**From:** Stephen O'Kane [stephen.okane@AES.com]
**Sent:** Tuesday, October 23, 2012 6:07 PM
**To:** Chris Perri
**Cc:** Robert.Mason@CH2M.com; 'Jerry.Salamy@CH2M.com'; McKinsey, John A.; Foster, Melissa A.; Miller, Felicia@Energy
**Subject:** RE: HBEP emission rates and modeling results
**Attachments:** Attachement_1.pdf; SCAQMD response letter 10-23-2012.pdf; Attachement_2.pdf; Turbine Data

**RE: Huntington Beach Energy Project Permit Application (Facility ID# 115389)**

AES Huntington Beach, LLC (AES-HB) is submitting this letter in response to the October 5, 2012 South Coast Air Quality Management District's (AQMD) electronic mail request for additional information needed to complete the Huntington Beach Energy Project (HBEP) engineering evaluation. Listed below are your specific requests followed by AES-HB's response.

**ATTACHMENT 1**
**AES HBEP Start Up Curve**
AES Huntington Beach Energy Project
*Huntington Beach, California*

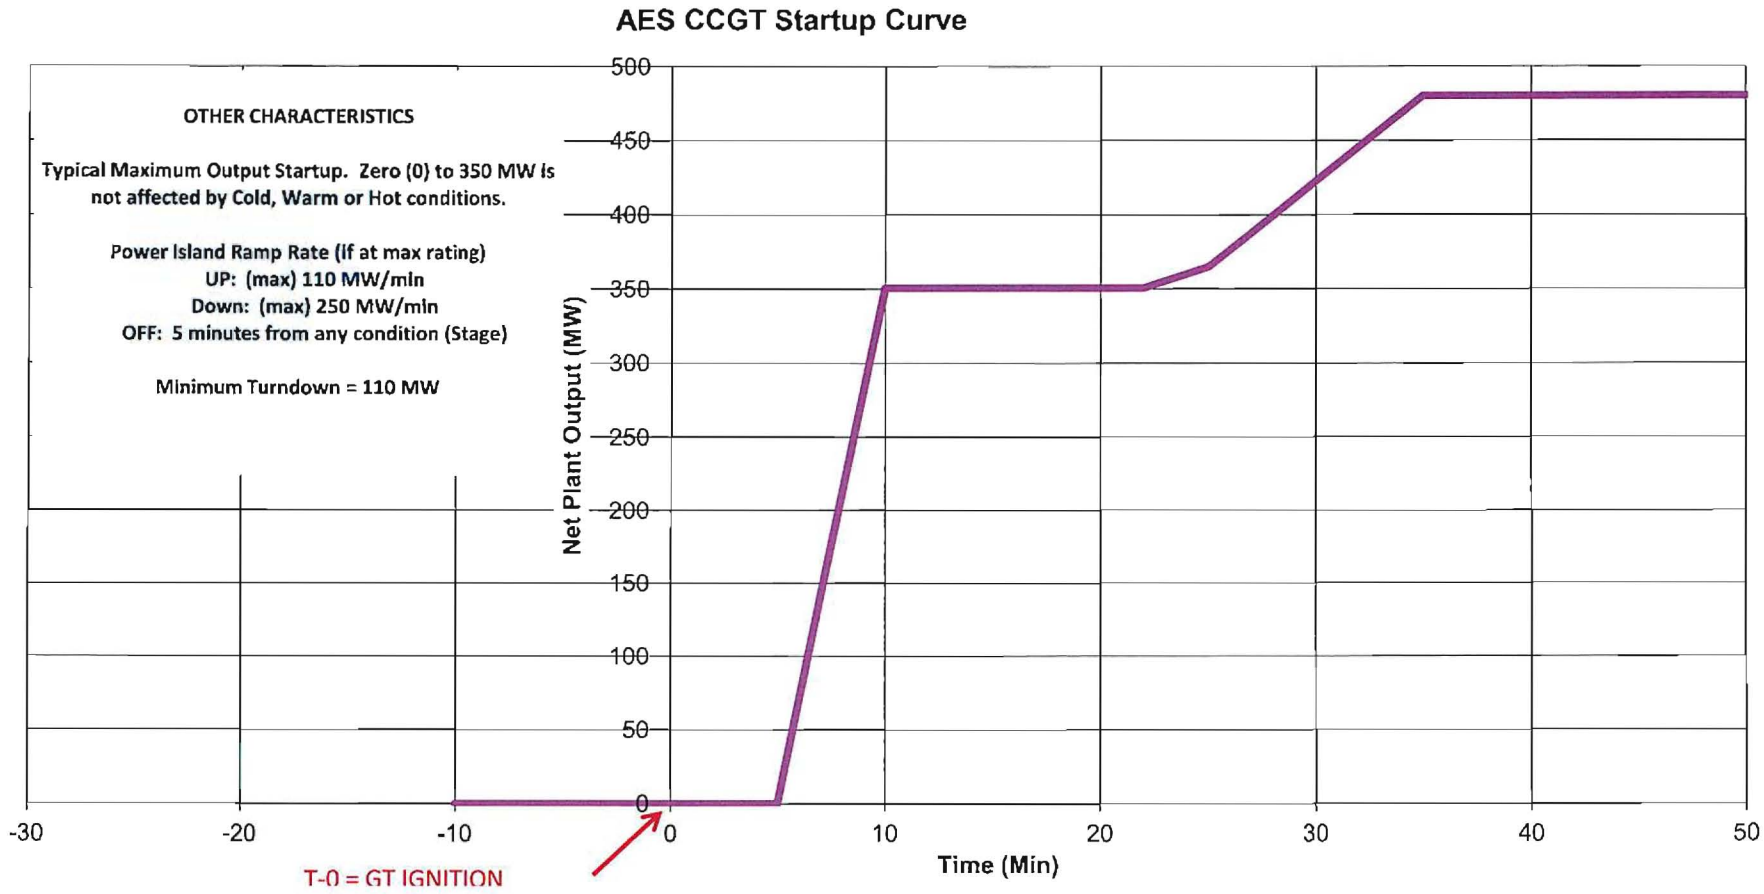
*SCAQMD-DR3: The 1 hour NOx should be done using stack parameters that correspond to a cold start up, unless you can justify that case 15 simulates a cold start up.*

**Response:** The overall duration of a cold, warm, or hot start (i.e., time required to achieve BACT levels) is dependent on the SCR and oxidation catalyst systems reaching minimum operating temperatures as well as the conditions of the steam cycle. However, because of the HBEP turbine's rapid start technology, the duration required from initiation of fuel to the turbine reaching 100 percent load is only 10 minutes for all three startup scenarios (hot, warm, and cold). Attachment 1 presents a startup curve for the turbine.

Therefore, the Applicant expects that the turbines will be able to operate at a minimum of 70 percent operating load rate from 10 minutes through the time when the emission control systems are fully functional during all starts (i.e., the remaining 50 minutes of the hour). Because the 1-hour $NO_2$ modeling presented in the permit application assumed the maximum hourly cold start up emission rate for NOx of 25.5 lb/hr for turbine exhaust conditions at 70, 80,
